WILLOW PLACE

RE: SUB 2000-03 -- One-Step Final Plat of WILLOW PLACE ADDITION

RE: SUB 2000-03 -- One-Step Final Plat of WILLOW PLACE ADDITION

STAFF REPORT
(One-Step Final Plat Approved 3/09/2000)

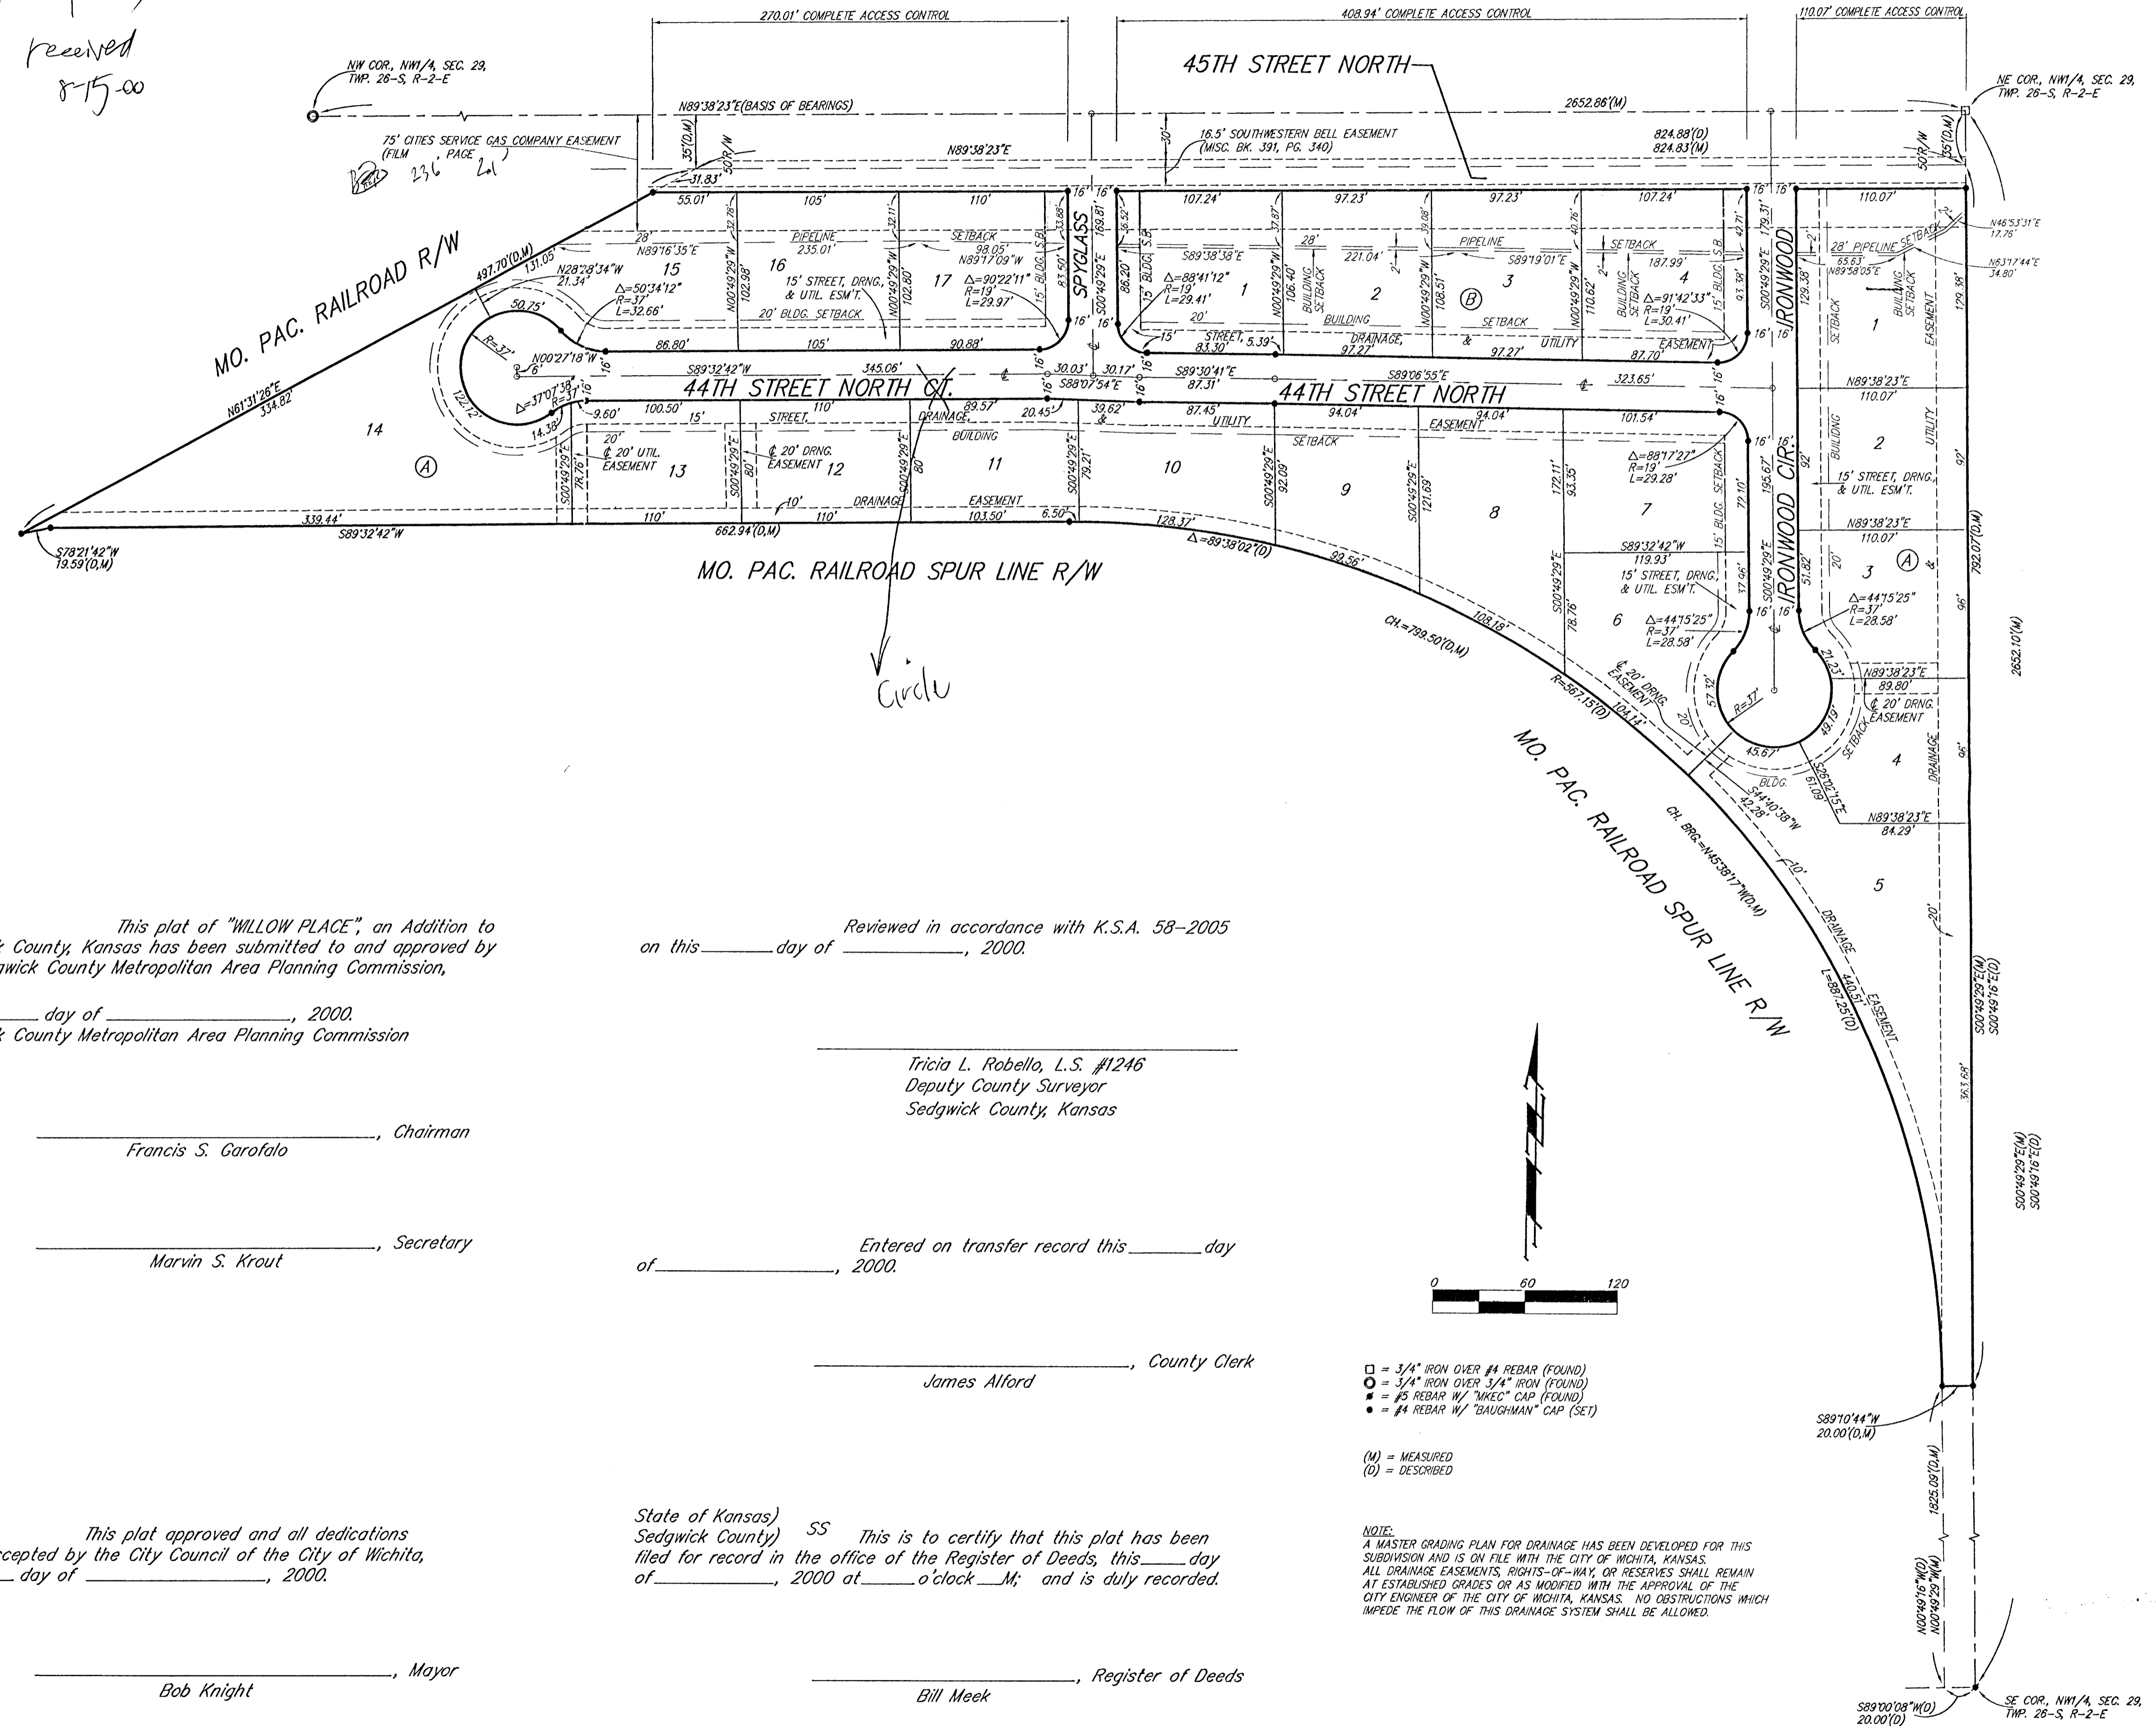
- E. The plat shall dedicate complete access control along the site's frontage to 45th St. North. The access controls shall be referenced in the plat's text.

- H. City Fire Department needs to comment on the acceptability of the street names. Willowplace should be revised to 44th St. North.

- I. Since this plat proposes the platting of narrow street right-of-way with adjacent "15-foot street drainage and utility easements", a restrictive covenant shall be submitted which calls out restrictions for lot-owner use of these easements. Retaining walls and change of grade shall be prohibited within these easements as well as fences, earth berms and mass plantings.

- K. The applicant's agent shall determine any setback requirements for the pipelines by researching the text of the pipeline agreements. If a setback from the pipeline easements is provided for in the pipeline easement agreements, it shall be indicated on the face of the plat.

- L. The building setback lines may be eliminated from the area located within the pipeline easement.
- M. Block numbers need to be designated.
- N. The bearing along the north section needs to be corrected.

- O. Since this plat is not a replat, the surveyor's text should not include reference to KSA 12-512(b).
- P. Traffic Engineering should comment on the need for improvements to 45th St. North. ***No improvements are required. The location of Spyglass shall be relocated eastward between Lots 1 and 2, to increase the distance from the railroad.***

- Q. City Engineering requests the addition of radii at the intersections of the internal streets.
- R. Notice of Protective Overlay document indicating the Protective Overlay has been filed with the MAPD shall be submitted.
